Access Compliance Report

Public Rights-of-Way

(Curb Ramps)

Intersection ID: 27731	Main Street: BALCH_MANOR_CT	Cross Street: BREM_LN	Location:	N
ADA ID: 4BB4D7B7A68E	Ramp Type: Perp	Initial Pass/Fail: Fail	Overall Compliance: No	Severity Score: 26.25
Codes/Mitigation Info/Possible Solution		Field Measurements/Component Compliance

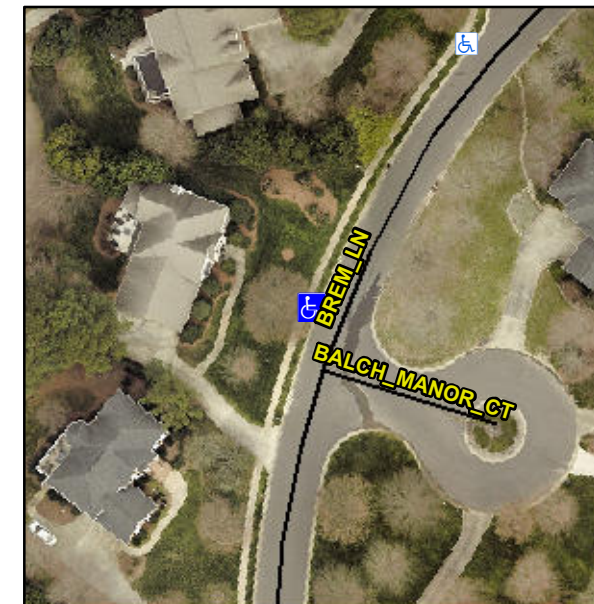
Not Found, R304.2.2

Compliance	Description	Data	Compliance	Description	Data
N/A	Ramp Length (in)	48.0	No	Ramp Slope (%)	17.3
Yes	Ramp Width (in)	60.0	Yes	Ramp XSlope (%)	3.2
N/A	Flare Type LT	N/A	N/A	Flare Type RT	N/A
N/A	Flare Slope LT (%)	N/A	N/A	Flare Slope RT (%)	N/A
N/A	Flare Traversable LT?	N/A	N/A	Flare Traversable RT?	N/A
N/A	Landing Length (in)	N/A	N/A	DWS Provided?	N/A
N/A	Landing Width (in)	N/A	N/A	DWS Contrast?	N/A
N/A	Landing Slope (%)	N/A	N/A	DWS Length (in)	N/A
N/A	Landing X Slope (%)	N/A	N/A	DWS Full Width?	N/A
N/A	Landing Curb? (Y/N)	N/A	N/A	DWS Offset (in)	N/A
N/A	Shared Landing?	N/A			
N/A	Gutter Ponding?	N/A	N/A	Gutter Slope (%)	N/A
N/A	Gutter Lip Ht (in)	N/A	N/A	Gutter X Slope (%)	N/A
N/A	Painted X Walk1?	No	N/A	Painted X Walk2?	N/A
	X Walk 1 Direction	To SE		X Walk 2 Direction	N/A
N/A	X Walk 1 Width (in)	N/A	N/A	X Walk 2 Width (in)	N/A
	X Walk 1 Slope (%)	5.3		X Walk 2 Slope (%)	N/A
	X Walk 1 X Slope (%)	3.4		X Walk 2 X Slope (%)	N/A

Remove & Replace Entire Ramp.
